ADDENDUM No. 1

March 7, 2023

BID DOCUMENTS dated 02/06/2023

CITY OF CANTON – SANITATION BUILDING PROJECT – GP 1376

UTILITY PLAN

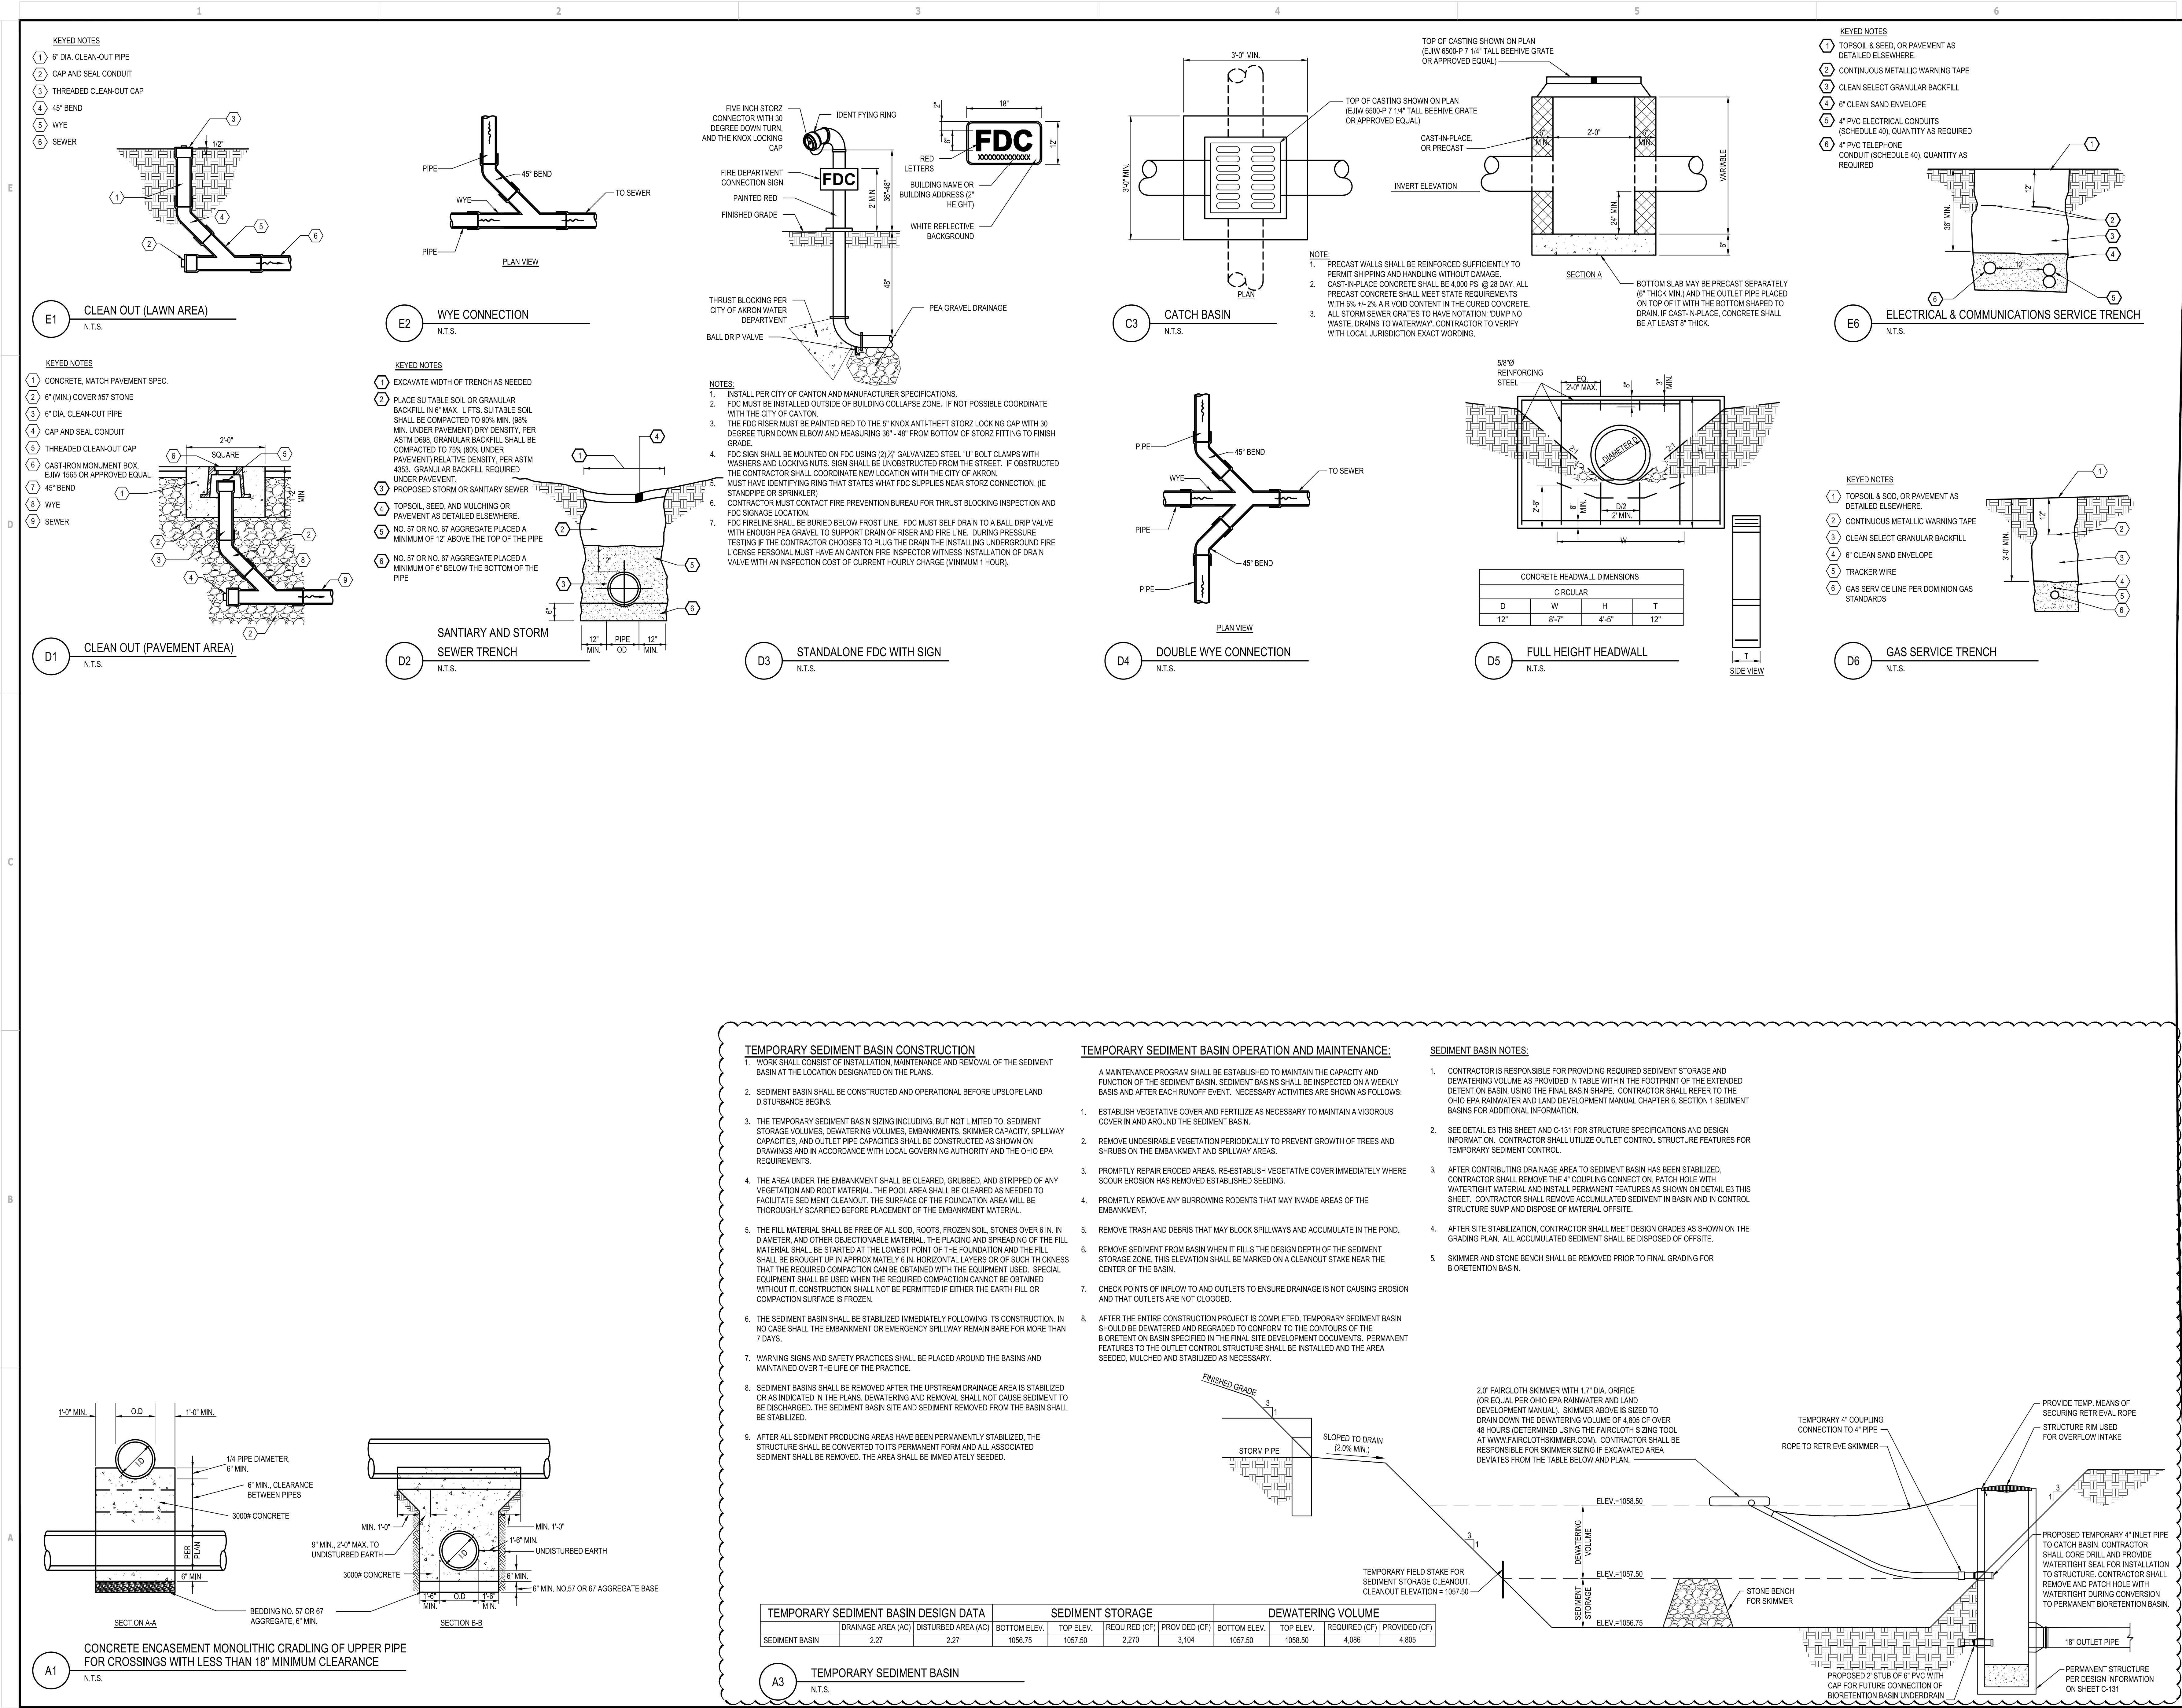
- 8. C-122 GRADING ENLARGEMENT
 - a. Revised curbing at garage to show flush curbing.
- 9. C-131 UTILITY PLAN
 - a. Added proposed ODOT 2-2A catch basin with a window on north side.

- b. Revised OW-1 to add callout for detail on sheet C-503.
 - c. Updated proposed domestic water to be 4".
 - d. Updated domestic and fire line to be tapped off existing main at north side with a tee and separate lines run to proposed connections at the building. All associated keynotes revised.

- e. Added note #6 to Utility crossing notes.
 - f. Keynote updated to see proposed profile on Sheet C-132 for connection information.
- 10. C-132 SANITARY PUMP STATION NOTES AND PLAN

C-504

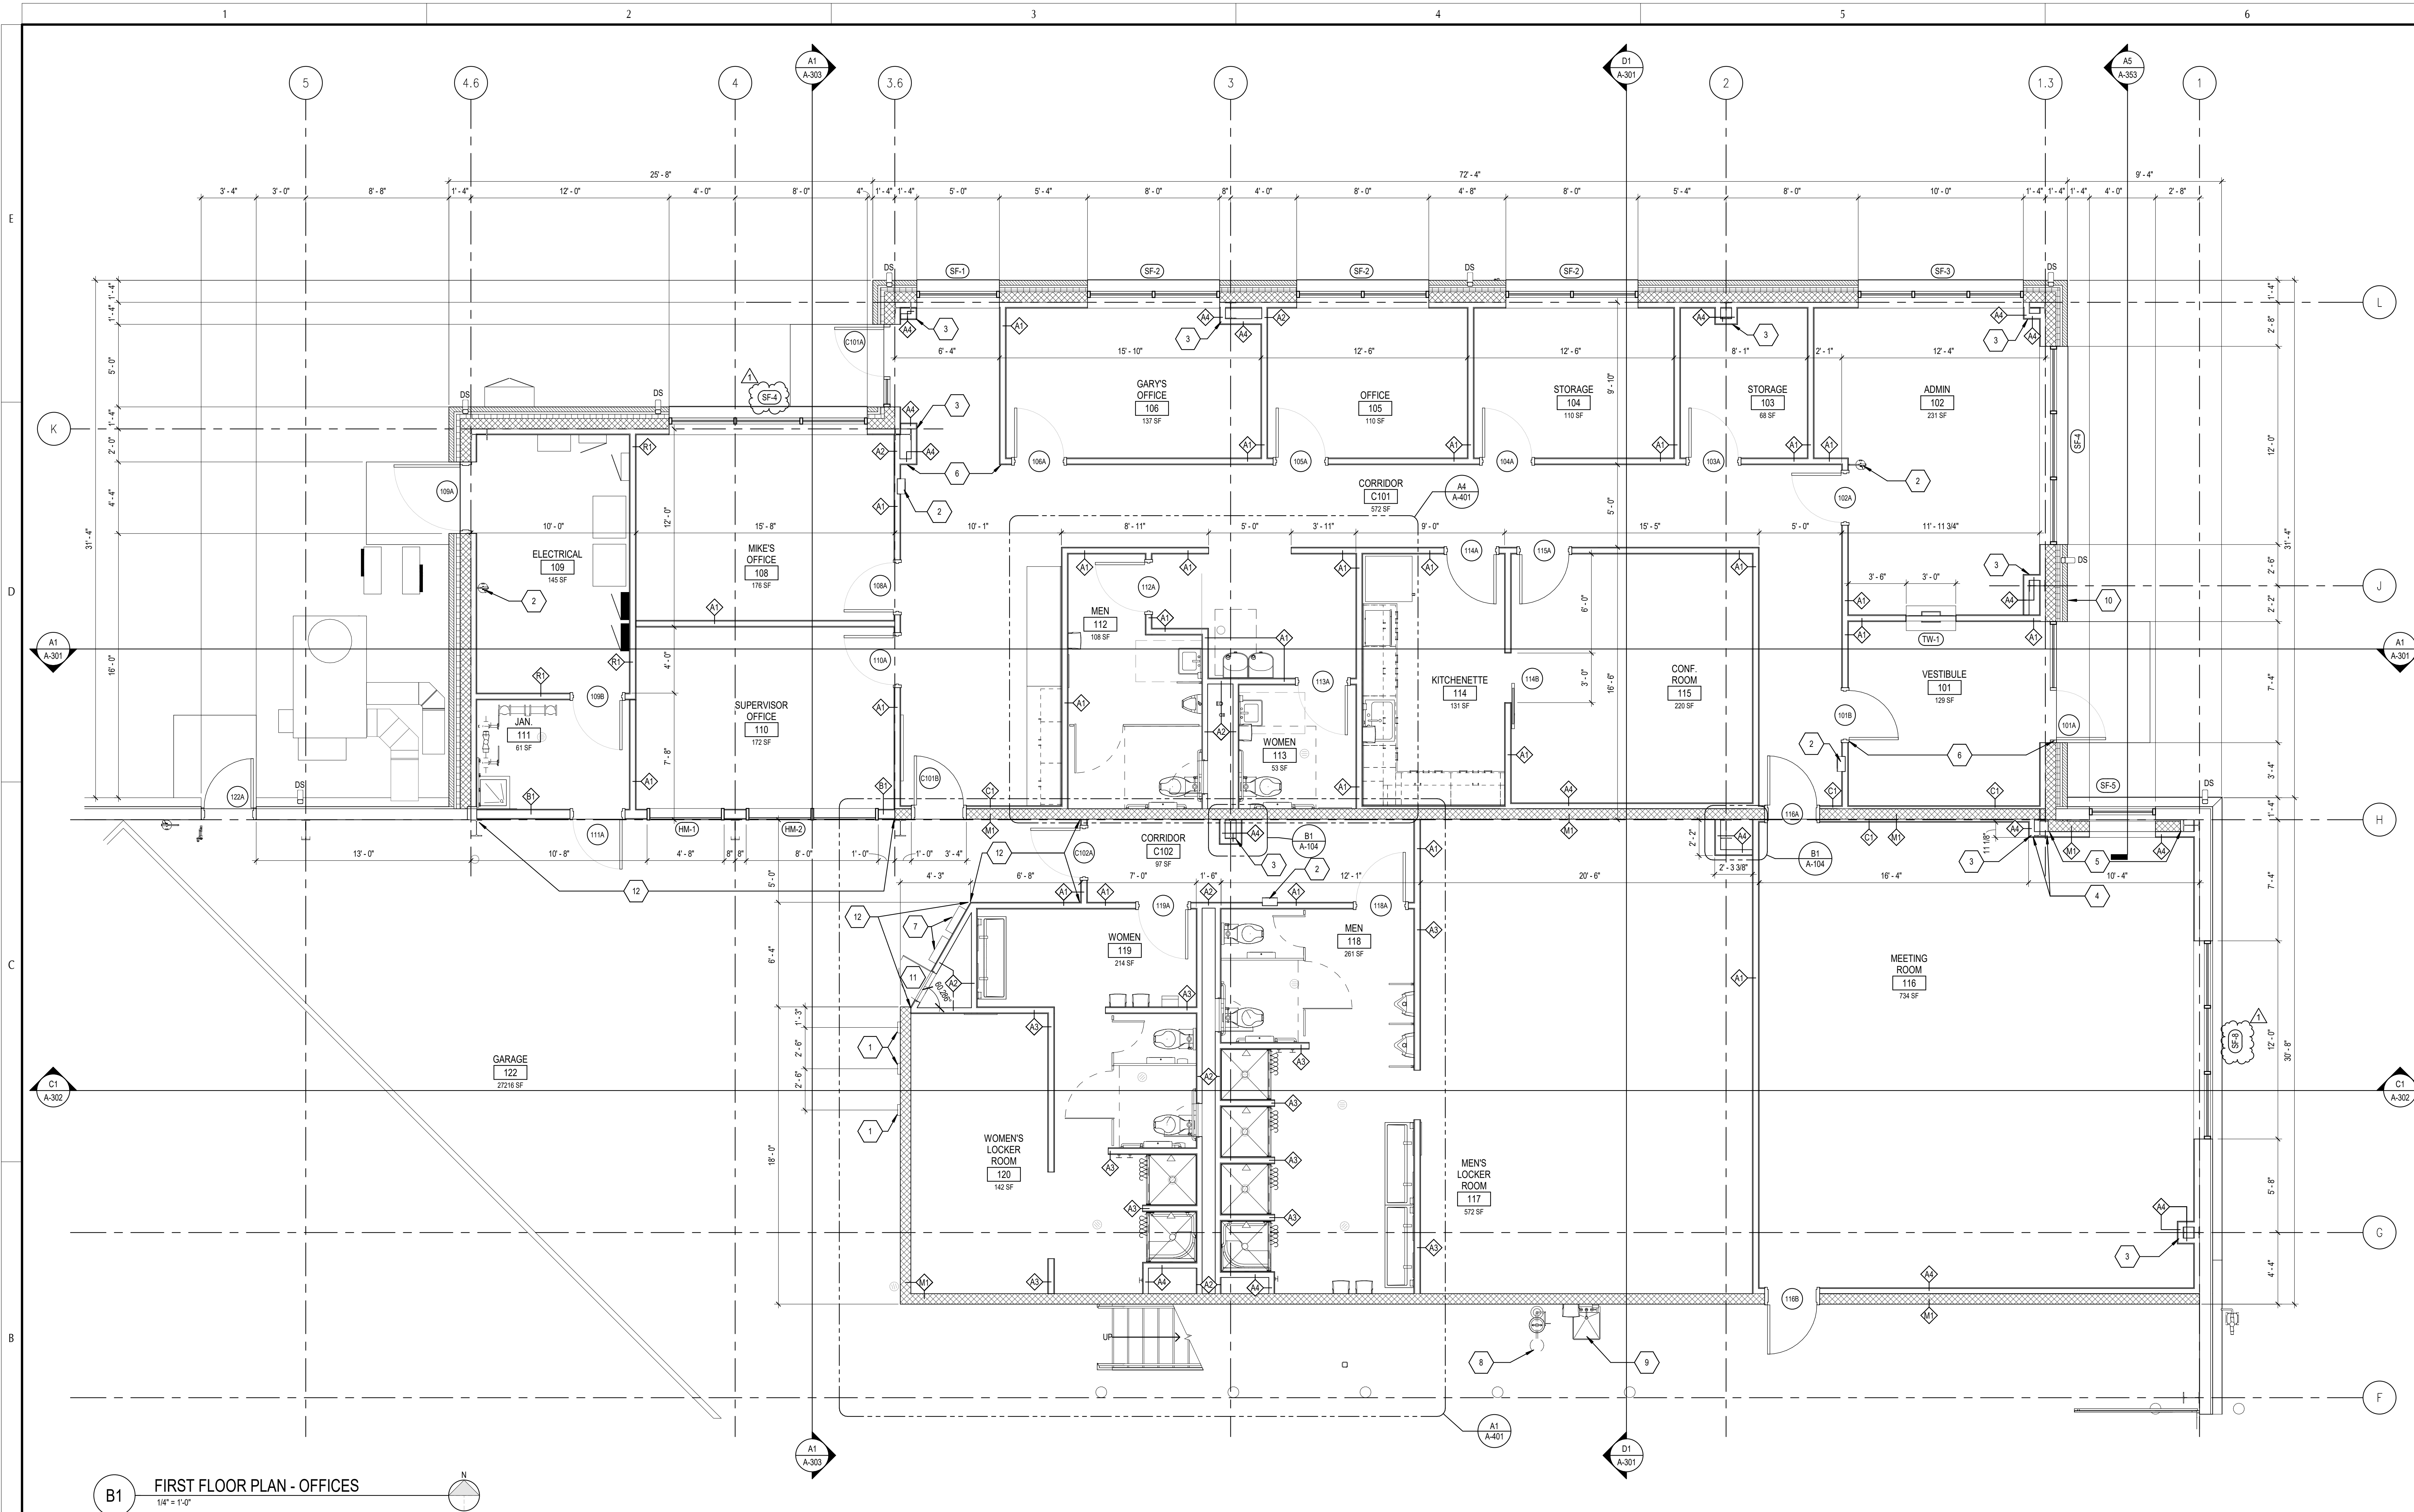
- b. Added City of Canton acceptable water service materials list.
- 14. C-504 DETAILS
 - a. Added Motorized Gate details.
- 15. A-102 ENLARGED OFFICE PLAN

B3 SF-8
1/4" = 1'-0"

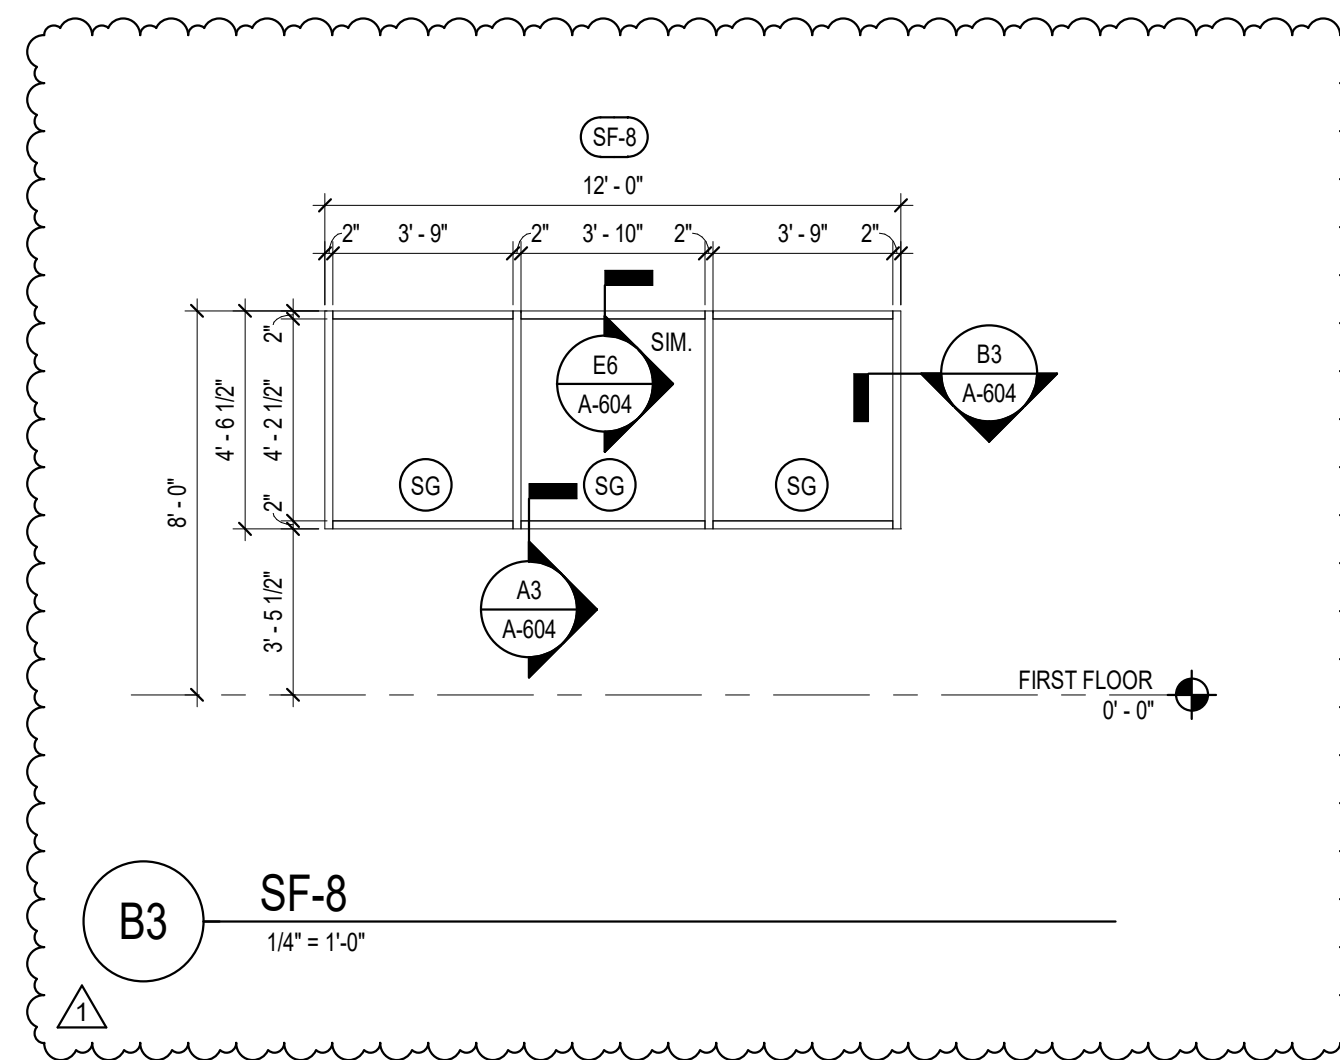
- a. Added window elevation SF-8 Drawing B3

C1 WINDOW SILL DETAIL
1 1/2" = 1'-0"

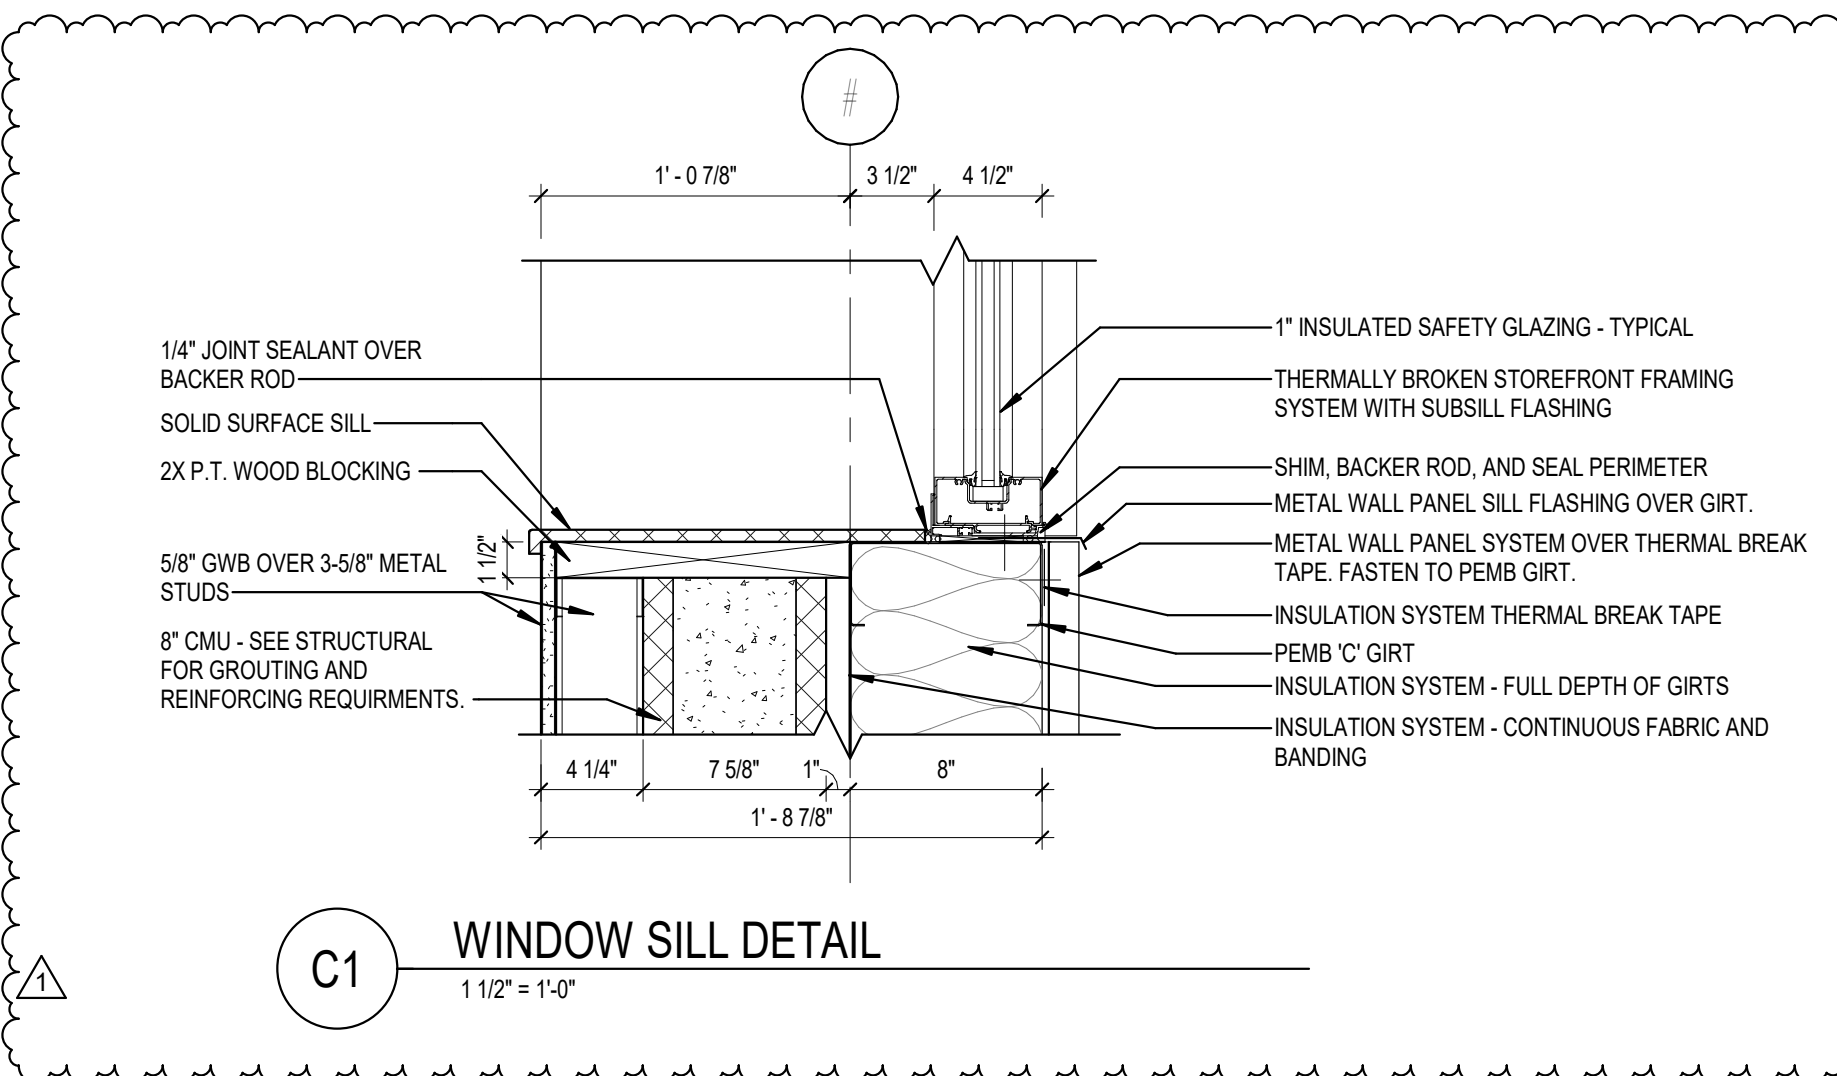
- a. Added window sill detail Drawing A3
- b. Added window jamb detail Drawing B3
- c. Modified window sill detail Drawing C1
